MerCruiser Guardian Low Water Pressure Fault

Models Affected

| Models Covered | Serial Number Or Year |
|------------------------------|-----------------------|
| 4.3L MPI RWC EC Alpha models | 1A645142 and above |

Current water pump kit

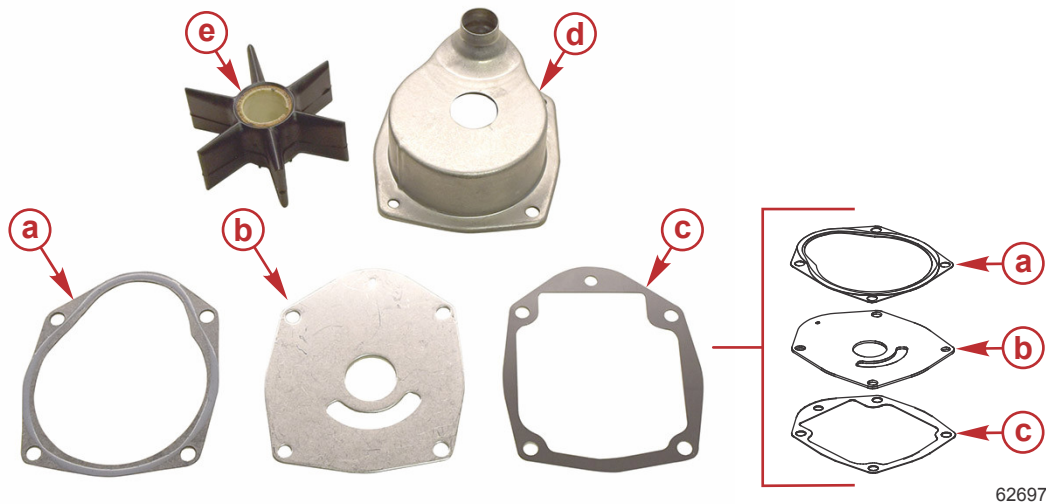
6. Replace the sterndrive water pump components with an appropriate complete water pump kit. The rubber overmolded faceplate must be replaced with a metal faceplate without rubber. Refer to the illustration below for the proper installation sequence of the faceplate and gaskets.

NOTE: Ensure you have a current water pump kit without the overmolded faceplate. It is not acceptable to reinstall kits that contain an overmolded faceplate.

- a - Fiber gasket with neoprene bead
- b - Faceplate
- c - Metal gasket
- d - Water pump cover
- e - Impeller
